Access Compliance Report

Public Rights-of-Way

(Curb Ramps)

Intersection ID: 11549	Main Street: MATHESON_AV	Cross Street: SIMPSON_DR	Location:	N
ADA ID: E405A62472B5	Ramp Type: Perp	Initial Pass/Fail: Fail	Overall Compliance: No	Severity Score: 21.25
Codes/Mitigation Info/Possible Solution		Field Measurements/Component Compliance

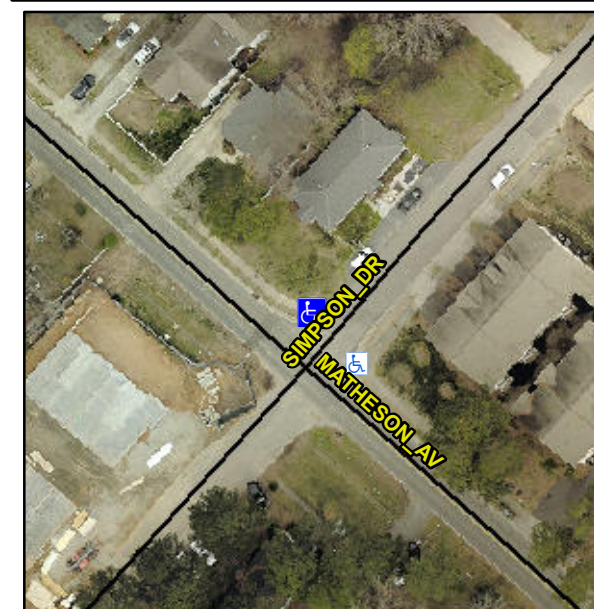
Not Found, R304.5.1, R304.2.2

Compliance	Description	Data	Compliance	Description	Data
N/A	Ramp Length (in)	53.0	No	Ramp Slope (%)	9.9
No	Ramp Width (in)	43.0	Yes	Ramp XSlope (%)	1.3
N/A	Flare Type LT	N/A	N/A	Flare Type RT	N/A
N/A	Flare Slope LT (%)	N/A	N/A	Flare Slope RT (%)	N/A
N/A	Flare Traversable LT?	N/A	N/A	Flare Traversable RT?	N/A
N/A	Landing Length (in)	N/A	N/A	DWS Provided?	N/A
N/A	Landing Width (in)	N/A	N/A	DWS Contrast?	N/A
N/A	Landing Slope (%)	N/A	N/A	DWS Length (in)	N/A
N/A	Landing X Slope (%)	N/A	N/A	DWS Full Width?	N/A
N/A	Landing Curb? (Y/N)	N/A	N/A	DWS Offset (in)	N/A
N/A	Shared Landing?	N/A			
N/A	Gutter Ponding?	N/A	N/A	Gutter Slope (%)	N/A
N/A	Gutter Lip Ht (in)	N/A	N/A	Gutter X Slope (%)	N/A
N/A	Painted X Walk1?	No	N/A	Painted X Walk2?	N/A
	X Walk 1 Direction	To SE		X Walk 2 Direction	N/A
N/A	X Walk 1 Width (in)	N/A	N/A	X Walk 2 Width (in)	N/A
	X Walk 1 Slope (%)	3.8		X Walk 2 Slope (%)	N/A
	X Walk 1 X Slope (%)	4.3		X Walk 2 X Slope (%)	N/A

Remove & Replace Entire Ramp.
